1 INTRODUCTION

onemilegrid has been requested by Kinglake Cemetery Trust to undertake a Transport Impact Assessment of the proposed cemetery at 265 Whittlesea-Kinglake Road, Kinglake Central.

Onemilegrid has previously prepared a Transport Impact Assessment for Kinglake Cemetery, which was submitted to VicRoads for review, prior the submission of a planning application.

VicRoads have since reviewed the previous Transport Impact Assessment and in response have raised a number of comments, as presented in Appendix C, which are addressed within this report and summarised directly later.

Figure 1 Site Location

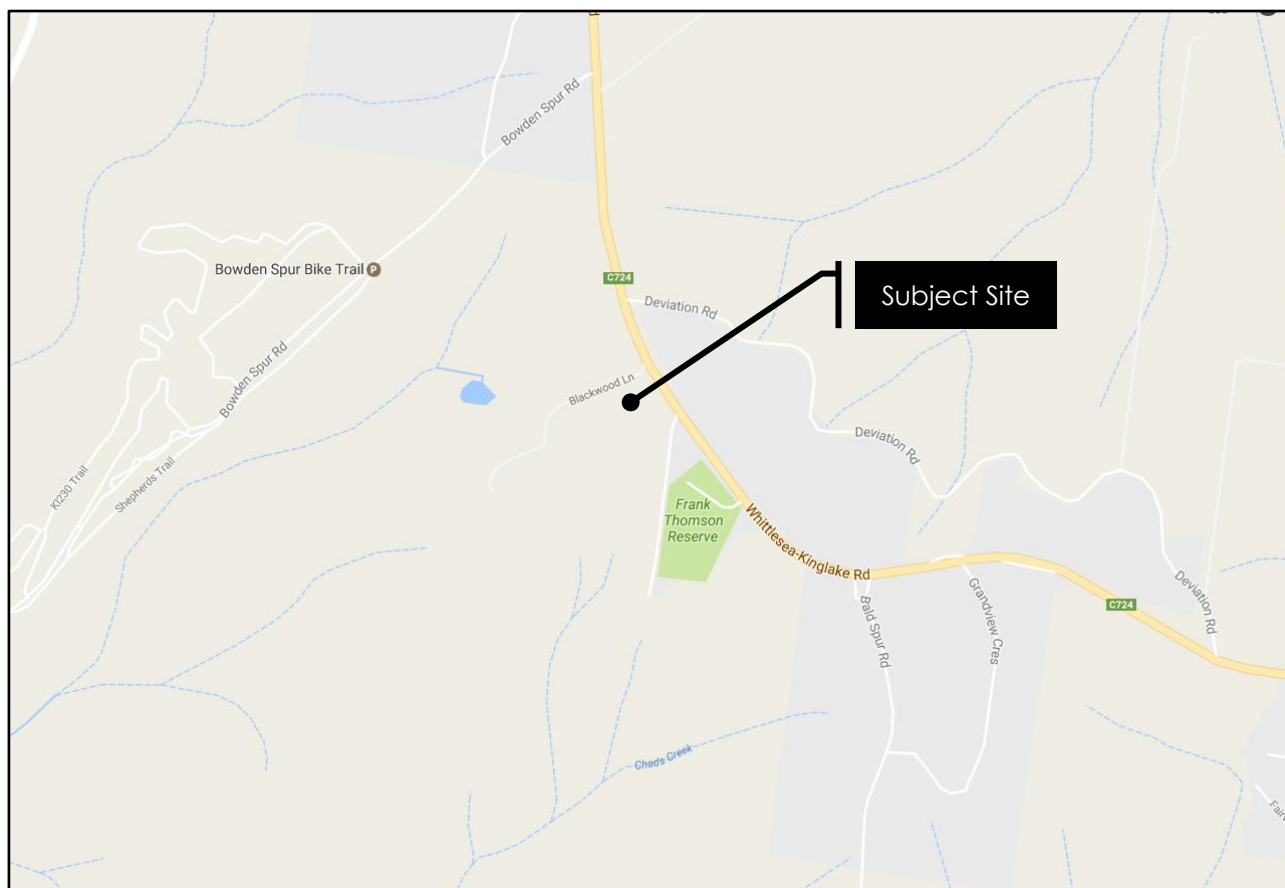
5	<p>Council has advised that objectors have raised concerns regarding heavy fog. I have advised Karen Girvan at Council that this climatic condition can effect many locations and motorist should drive in a manner that is appropriate for the prevailing climatic conditions. However, it would be appropriate for a recommendation to install intersection warning signs as part of the mitigating works at this intersection.</p>	<p>Noted. The report has been amended to adopt VicRoads suggestion of intersection warning signage as shown in Section 6.4 of the report.</p>
6	<p>The site location plan on Page 4 has been included to show where the development is proposed to occur and Figure 2 Planning Zones shows Deviation Road which should address the objectors concerns about lack of detail shown on the site location plan.</p>	<p>The site location plan has been updated to accurately reflect the location of Deviation road.</p>

Figure 7 Turn Lane Warrants – Design Speed < 100 km/h

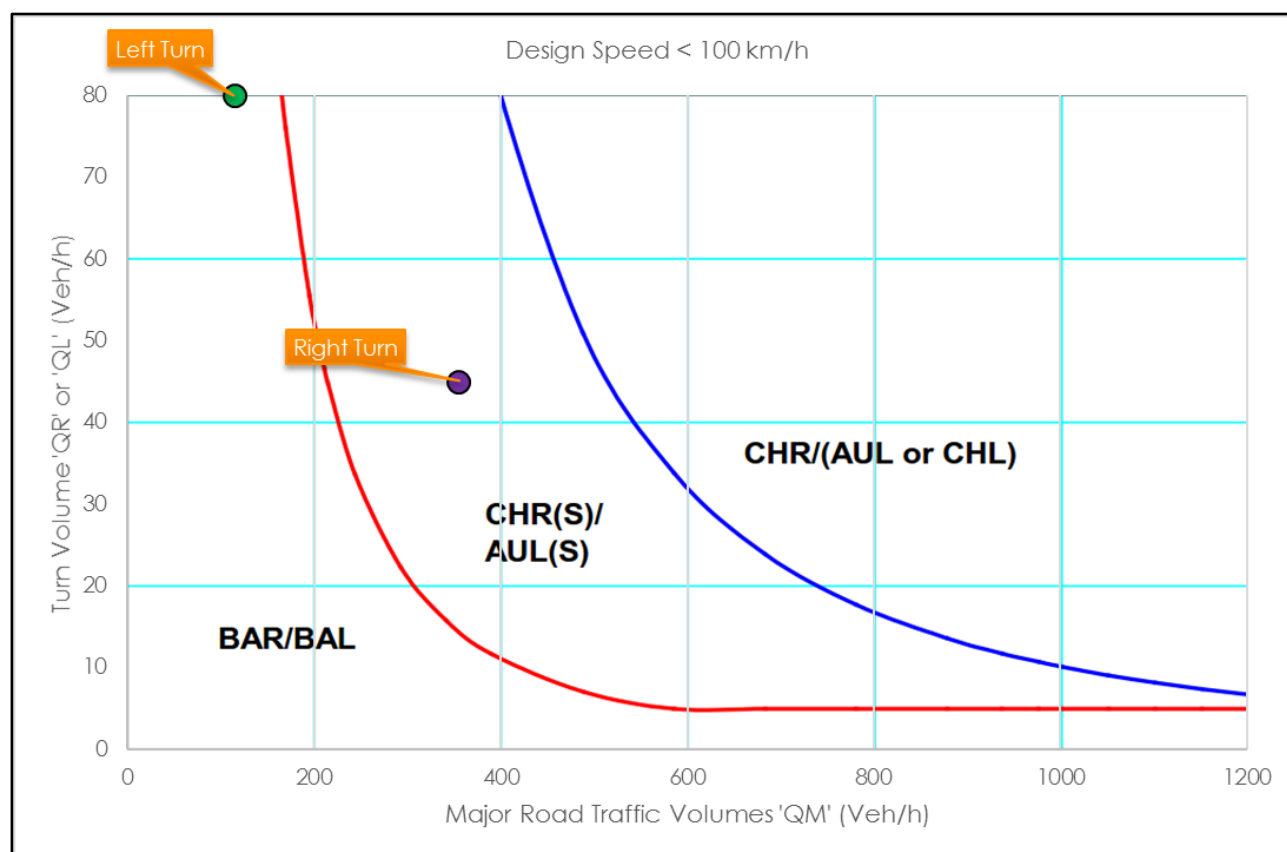
Comment Number	Issue Raised	Response
1	Section 4.1 incorrectly refers to Nillumbik Planning Scheme	The traffic report has been amended to reflect the development's location within the Murrindindi Shire Council.
2	Section 5.2 incorrectly lists St Peter's Anglican Church being located 1.8km south east which is actually approximately 0.6km and does not include the St Mary Catholic Church, which is located approximately 1.8km south east	Section 5.2 has been amended to reflect the locations of both St Peter's and St Mary's Churches.
3	Section 5.4 notes on the turn lane warrants diagram that a Channelised short right turn treatment CHR(s) is required, however the report then indicates that a short auxiliary right turn treatment is required but does not indicate the reasons for the why an AUR right turn treatment has been chosen. VicRoads supplement to the Austroads Guide does provide for the use of an AUR treatment in lieu of a CHR(s) but reasons need to be stated as to why the CHR(s) cannot be achieved or why it is not desirable to use a CHR(s). As stated in the supplement VicRoads should be consulted when considering the use of a CHR(S) versus a AUR treatment.	The intersection design has been amended to propose a CHR(s) treatment to Whittlesea-Kinglake Road at the intersection with Blackwood Lane. The CHR(s) treatment is considered to be a safer alternative to AUR(s). It is noted that there is no alteration to the geometry between the CHR (s) and the previously proposed AUR(s).

The turn lane warrants are within the range for a basic left turn treatment and a short channelised right turn treatment to be provided on Whittlesea-Kinglake Road.
